The Reclamation Division has conducted an initial review of BNI Coal's application for Bond Release No. 12 to Permit BNLS-8109 at the Larson Mine. The first two items listed below must be addressed before starting the publication of the newspaper notice and sending letters to landowners and agencies with notice of the bond release application. Please address these two items as soon as possible as we plan to schedule the bond release inspection for mid July.

Attachment V – Aerial Photo

Attachment VI – Tract...Success

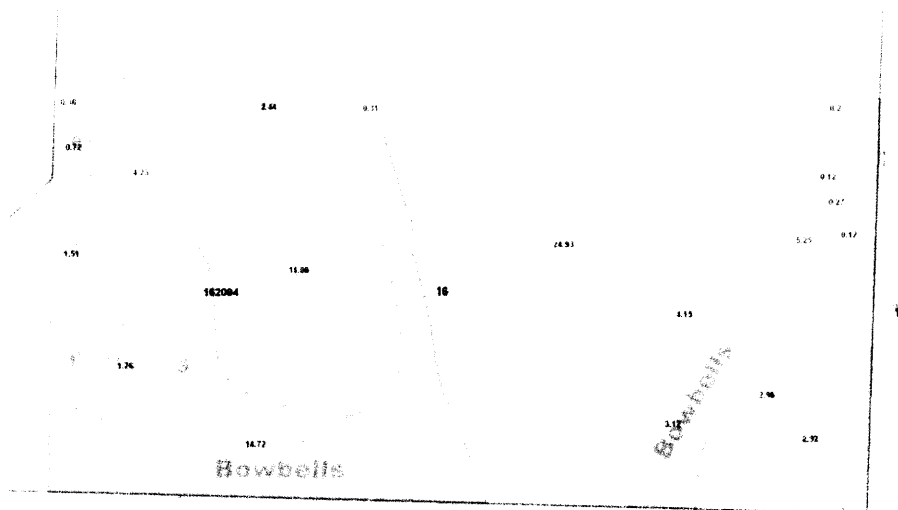
18. According to the Attachments V and VII only approximately 2.8 acres of Niobell Loam soil was disturbed, but the standards in Tables 2, 3 and 4 were computed using 6.0 acres of this soil mapping unit. It appears the pre-mine soil acreage difference should be applied to the Bowbells soil mapping unit as our calculations show there were approximately 18.5 acres of Bowbells in the pre-mine cropland. Also, the acreage of the pre-mine soils in the area occupied by the embankment for Pond 9 should not be used in these calculations. Please review and correct Tables 2, 3, and 4 as necessary. An image showing the acres of each mapping unit is shown below. (GAW)
